Planning Commission
CITY HALL COUNCIL CHAMBERS
AGENDA OF MARCH 11, 2025
7:00 PM

1. PPZ2025-0337: Victory Park, 7777 Victory Lane, PPN 07-00-003-102-106
Owner: PMJ Park Holdings, 7777 Victory Lane, North Ridgeville, OH 44039.
Proposal consists of new turf fields, lighting and other site improvements. Property zoned I-2 Light Industrial District.

The proposal consists of the installation of two turf fields, lighting and site improvements at Victory Park. The new fields are identified as Turf 3 and Turf 4 on the site plans provided. Turf 1 and Turf 2, existing to the west of the new fields, were installed in the last several years without going through the required Planning Commission review or permitting processes.

IMPROVEMENT PLANS
FOR
MULTI-SPORTS FIELDS AT VICTORY PARK
7777 VICTORY LANE
CITY OF NORTH RIDGEVILLE,
COUNTY OF LORAIN,
STATE OF OHIO

SHEET
2 OF 4
JOB NO.
25-6287

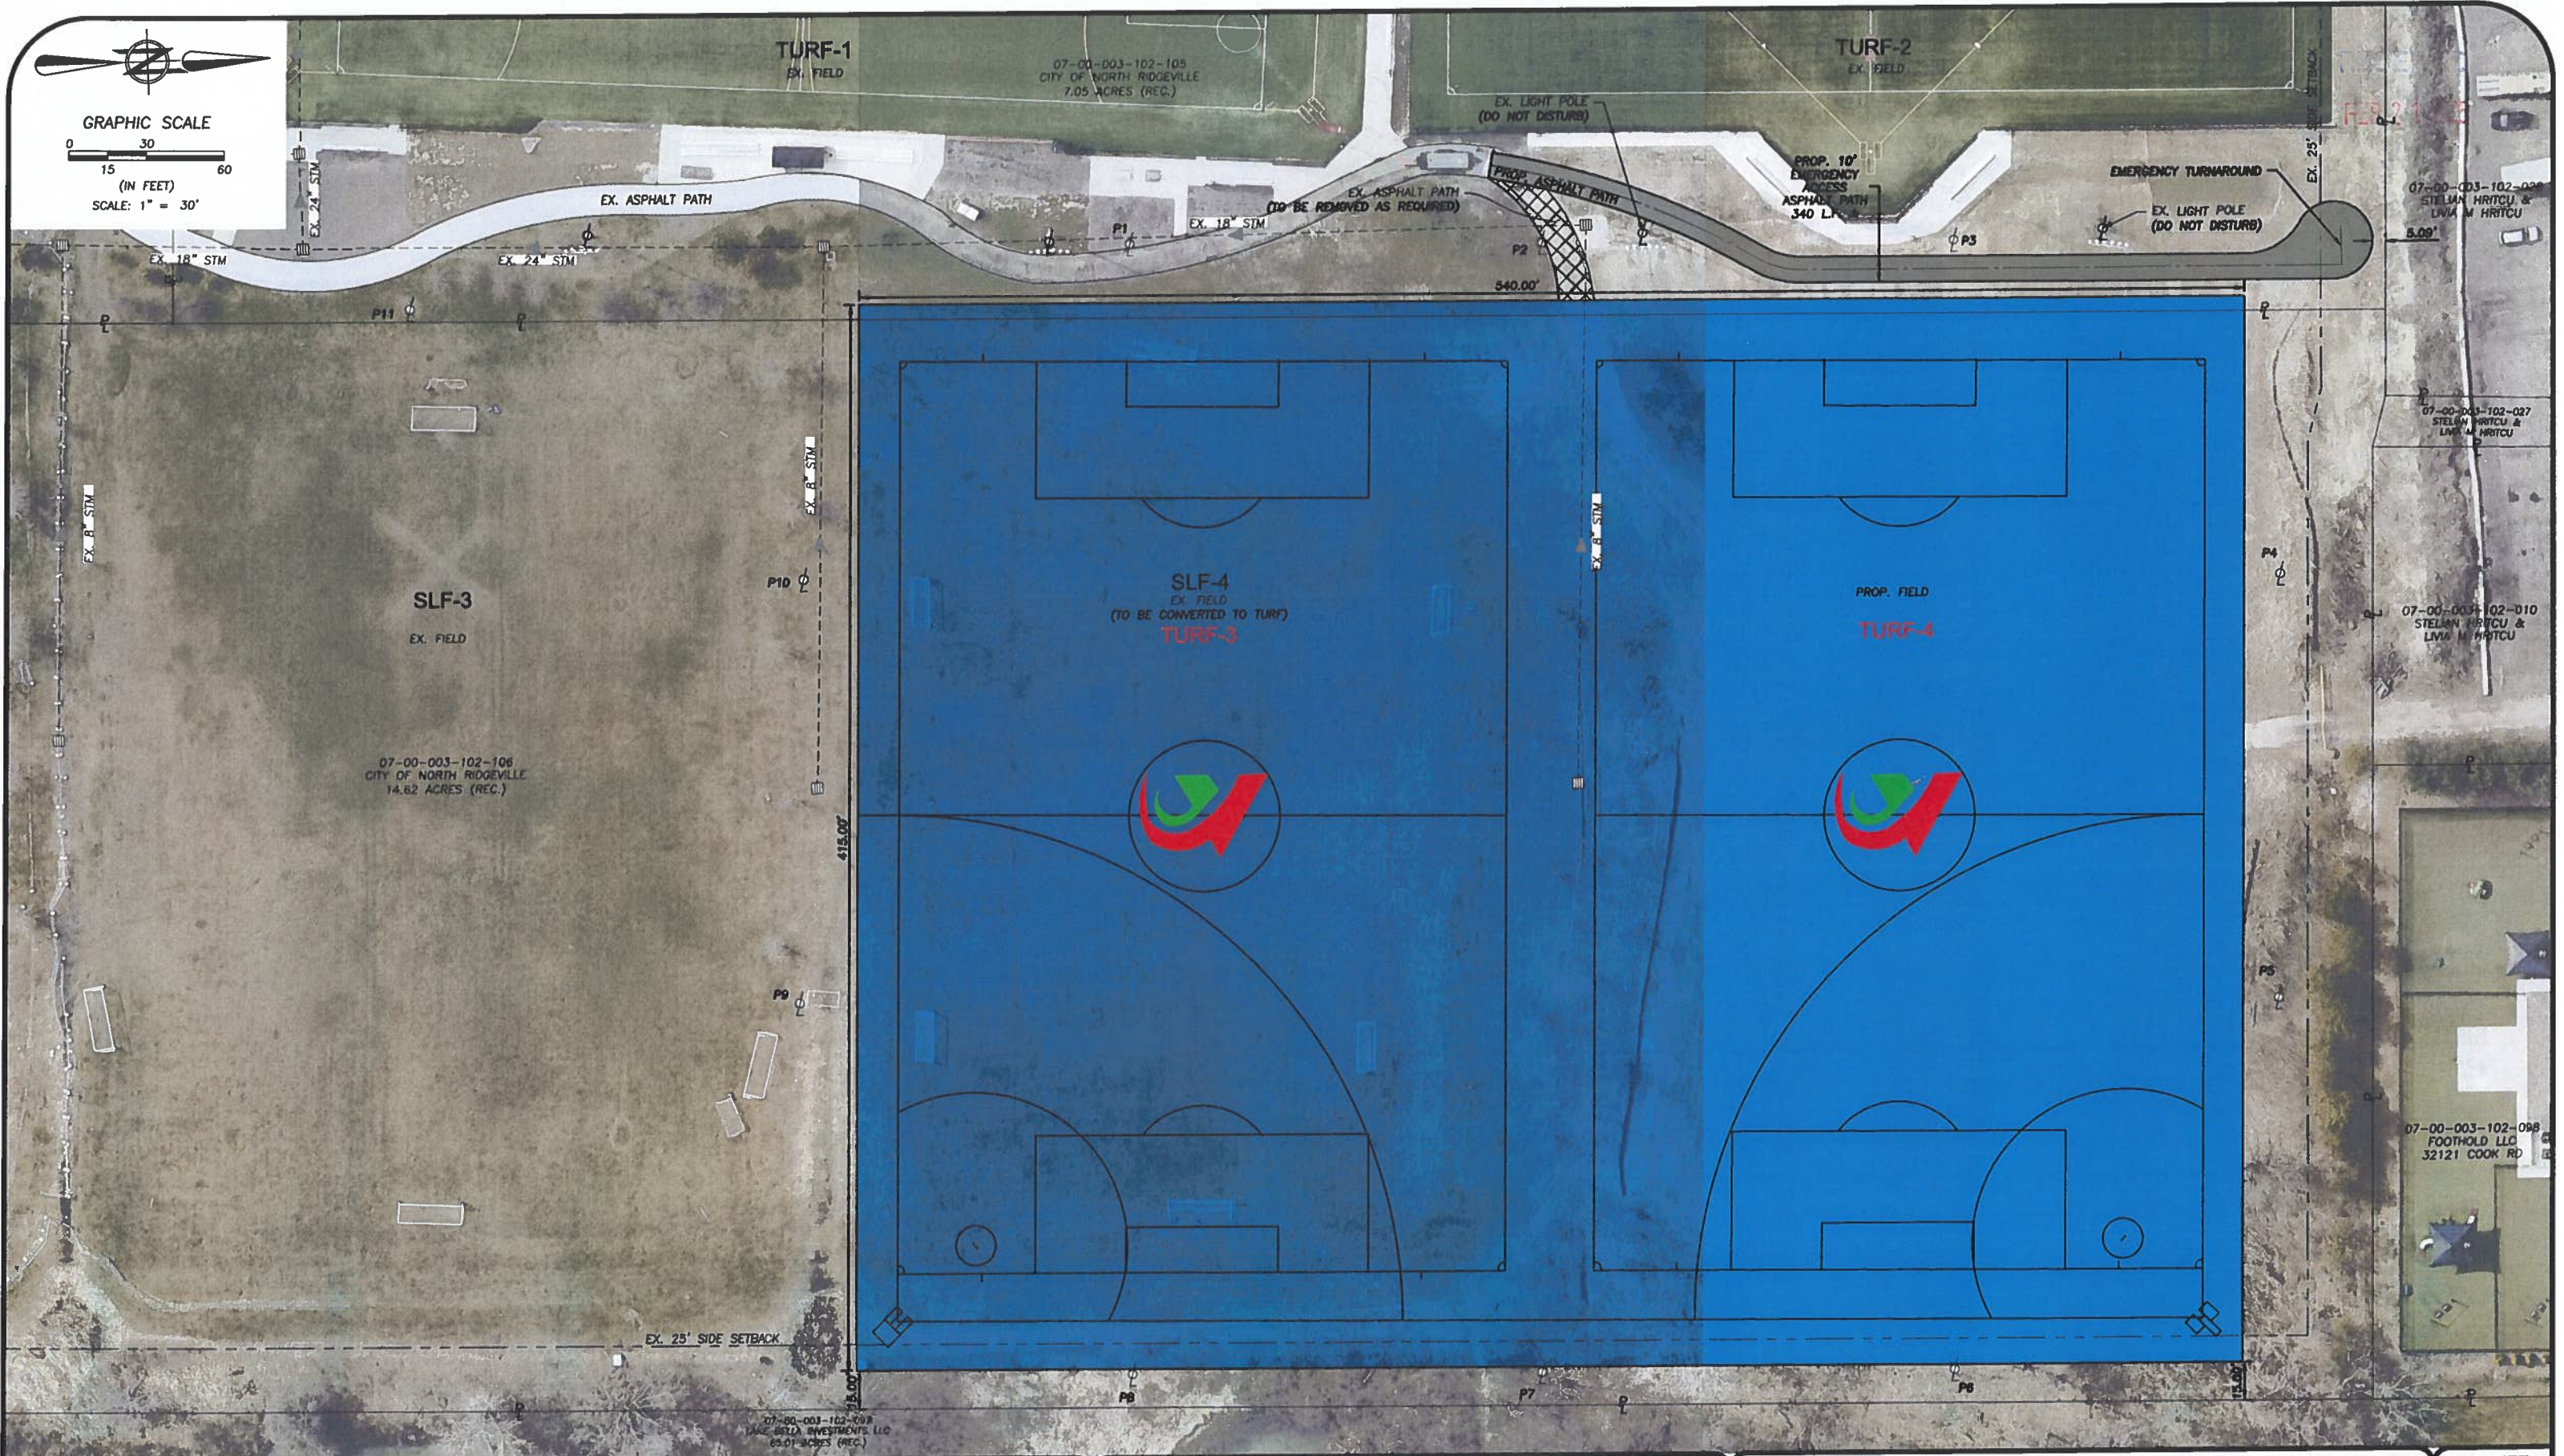
- Provide grading plan (1243.05(b)). New fields encroach 10 feet into “Ex. 25’ Side Setback.” Proposed Turf 3 is located in close proximity to lake. Will east end of fields be graded? Is tree clearing involved? How will erosion be prevented. Light fixtures also shown in close proximity to lake.
- Field surface shown 415 feet (E/W) by 540 feet (N/S). Width of PPN ending -106 is approximately 425 feet wide. Can field size be slightly reduced to better fit into space, allowing for room between east

- Provide access drive of sufficient width to accommodate emergency vehicles between Turf 2 and Turf 4.
- Provide truck turn exhibit and demonstrate turnaround is sufficiently sized to accommodate emergency vehicles.

VICTORY SPORTS PARK, NORTH RIDGEVILLE, OH

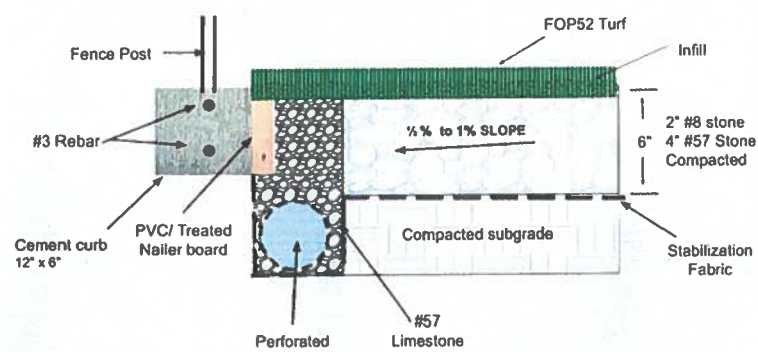
- Is spectator viewing provided?
- Provide specifications and cut sheets for exterior lighting fixtures (1285.08(b)(2)).
- Provide photometric plan showing light contributions from all sources on the site and show footcandle readings five feet beyond property lines (1285.08(b)(3)).

- P11 and P12 appear to be new poles. Provide photometrics.
- Provide setback of proposed light poles from north and east property lines.
- What hours will lights be terminated?

DATE:	REV.:	CHECKED BY:	SCALE: NTS
DRAWING NUMBER: MSP70M2EM	DRAWN BY: DR	QUOTE NUMBER:

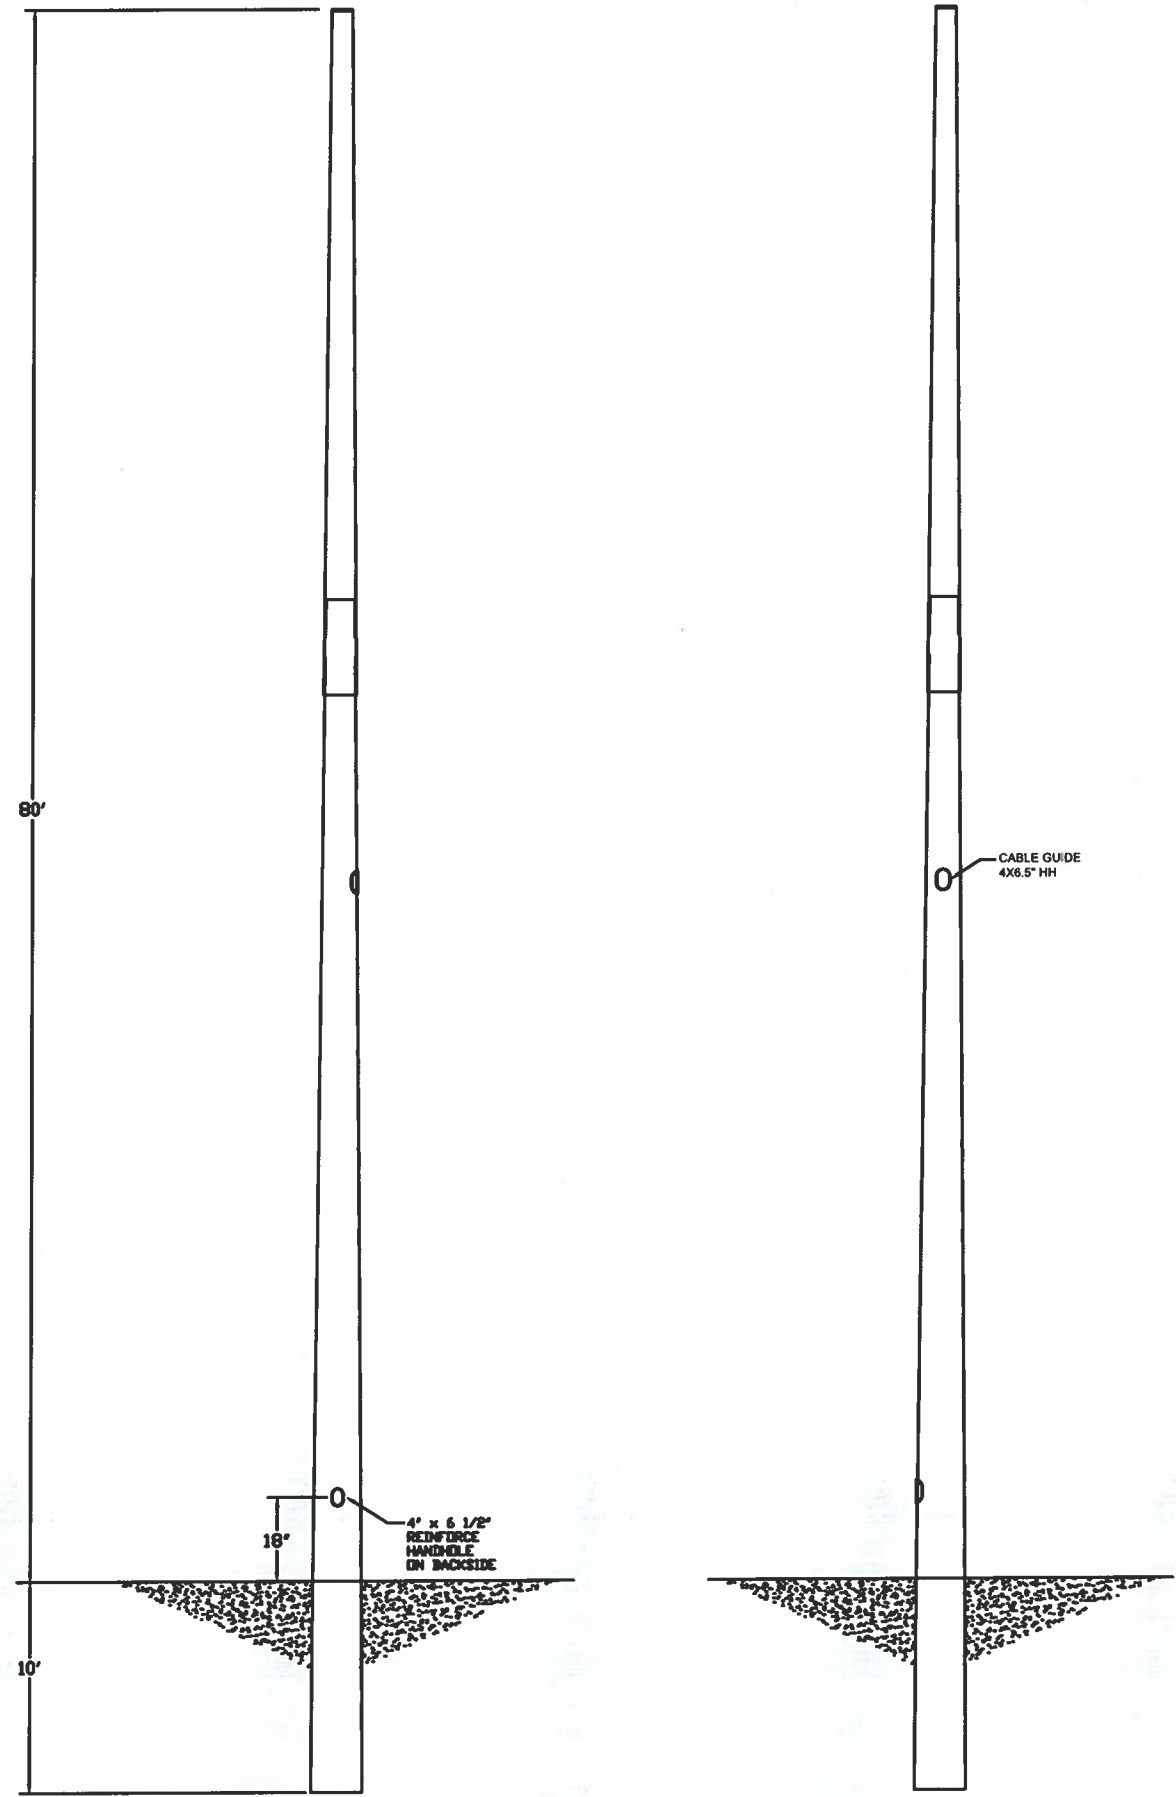
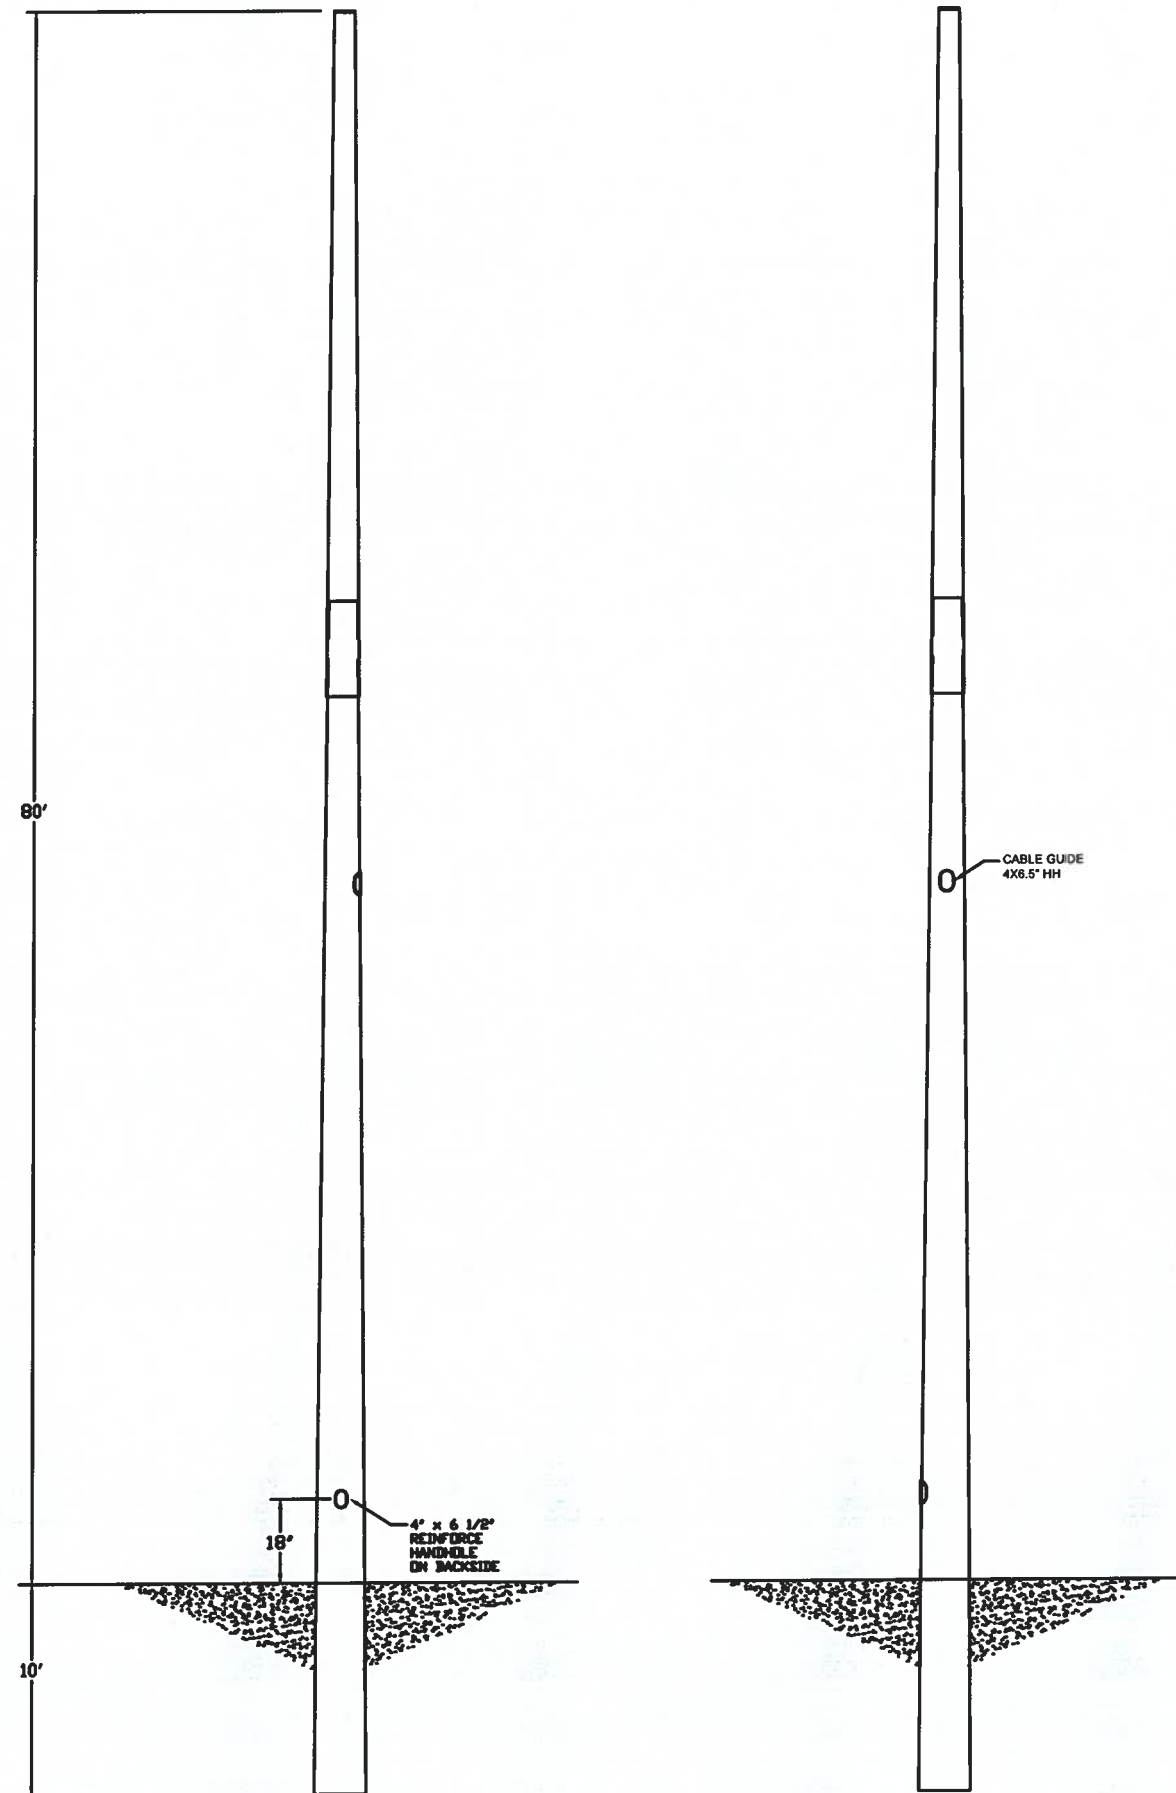
Please provide Engineered stamped drawings for light poles.
